THE MARYLAND-NATIONAL CAPITAL PARK AND PLANNING COMMISSION

DATE: May 29, 2002
TO: Montgomery County Planning Board
VIA: Joe Davis, Chief *JRD*
Development Review Division
FROM: Larry Ponsford AIA AICP, Supervisor *LRP*
Development Review Division
(301) 495-4576
PROJECT NAME: **Fairfield at Germantown**
CASE#: 9-02002
REVIEW TYPE: Project Plan
ZONE: RMX-2, R-200
APPLYING FOR: 610 garden apartments, 250,000 GSF office/retail on 62.4 acres
LOCATION: East of CSX tracks between MD #118 and Father Hurley Blvd.
MASTER PLAN: Germantown
REVIEW BASIS: Sec. 59-C-10 and 59-D-2 of Montgomery County Code
APPLICANT: F.F. Development, L.P.
FILING DATE: December 27, 2001
HEARING DATE: June 13, 2002

SUBJECT: Project Plan No. 9-02002
Fairfield at Germantown

Figure 13
 Total Future Lane Use and Traffic Control
 for Phase 2 (610 Units + 210,000 S.F. Retail,
 and 40,000 S.F. Office)

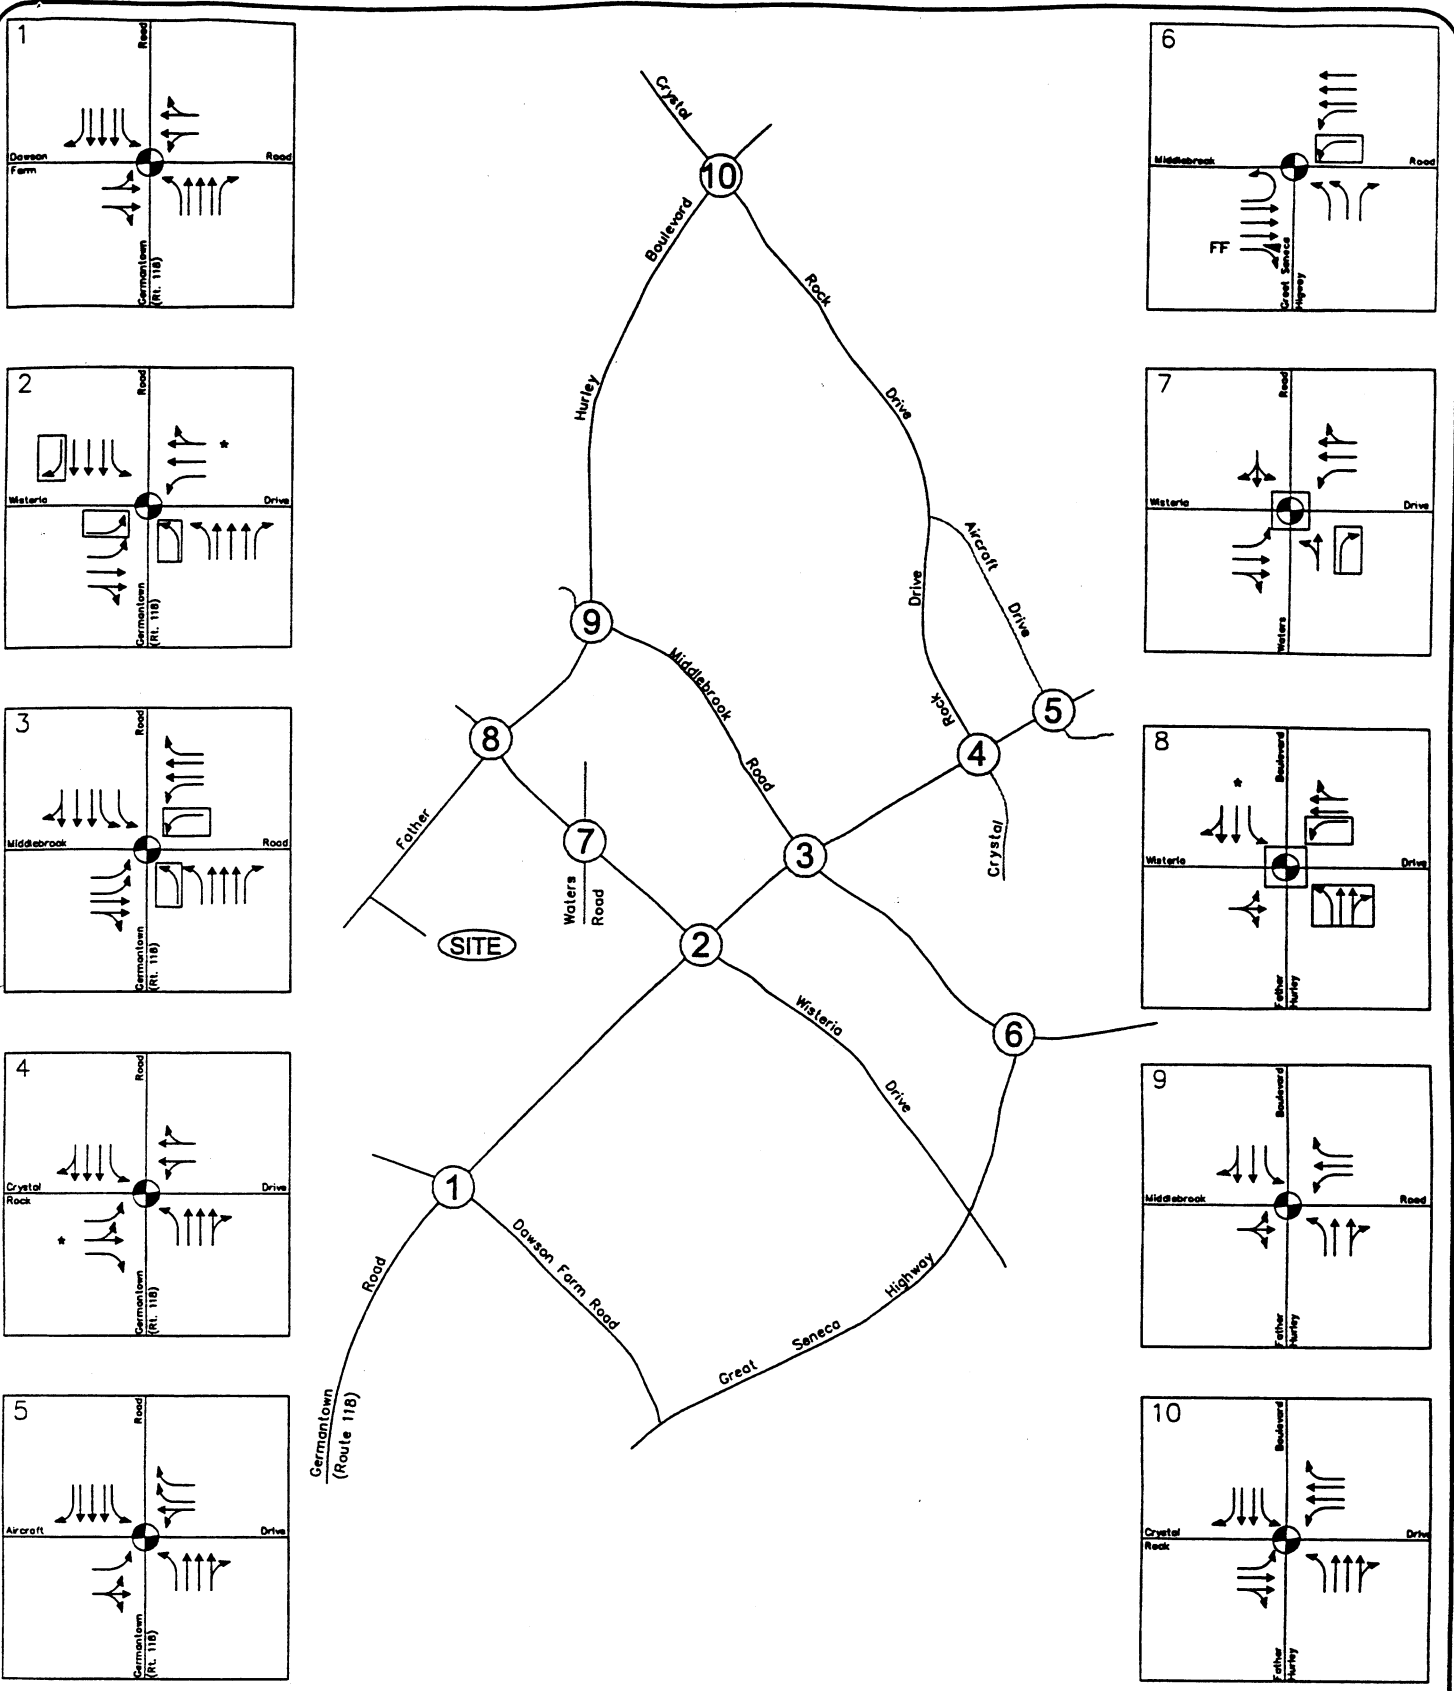
1. Total development under this project plan application is limited to the following uses and density:
 - 610 garden apartments
 - 210,000 square feet of retail space
 - 40,000 square feet of general office space
2. To satisfy Local Area Transportation Review:

- a. The applicant shall construct a separate southbound right-turn lane, a second northbound left-turn lane, a second eastbound left-turn lane, and restripe the separate westbound right-turn lane on Wisteria Drive as a shared through and right-turn lane (Phase 1) at the MD 118/Wistria Drive intersection.

- b. The applicant shall construct a second westbound left-turn lane (Phase 1), a second northbound left-turn lane, and modify the traffic signal to eliminate eastbound-westbound split phasing at the MD 118/Middlebrook Road intersection (Phase 1). Also, the applicant shall design and construct the removal of the channelized (free flow) located in the southeast quadrant of this intersection, provided monies required to be escrowed pursuant to Site Plan No. 8-84011A (Northlake Commerce Center –Condition 2) and Site Plan No. 8-98042 (Germantown Town Center Phase I – Condition 10) are available for the improvement and Preliminary Plan No. 1-99020 (north Germantown - Condition 1) participate in the improvement as required by its approval. (Phase 1)

- c. The applicant shall restripe the eastbound Crystal Rock Drive approach to provide a separate right-turn lane, a separate through and left-turn lane, and a separate left-turn lane at the MD 118/Crystal Rock Drive intersection. (Phase 1)

- d. The applicant shall construct a second westbound left-turn lane at the (Great Seneca Highway (MD 119)/Middlebrook Road intersection. (Phase 2)
- e. The applicant shall construct a separate northbound right-turn lane, restripe and designate existing Wisteria Center Lane for separate left-turn lanes, and install a new traffic signal if warrants and spacing criteria are met at the Wisteria Drive/Waters Road intersection. (Phase 2)

- f. The applicant shall construct a westbound left-turn lane on Wisteria Drive, a separate left and through lanes on Father Hurley Boulevard (FHB), and install a new traffic signal if warranted at the Father Hurley Boulevard intersection. (Phase 1)

- g. The applicant shall construct two lanes of Father Hurley Boulevard from Wisteria Drive SW to the site entrance, plus the full cross section of Father Hurley Boulevard from Wisteria Drive SW for a distance of approximately 600 feet, with final scope subject to pending minor realignment of father Hurley Boulevard by the Department of Public Works and Transportation (DPWT), to include a temporary transition from these six lanes to the two beyond. Final details are to be resolved as part of the Site Plan Review submission for Fairfield.
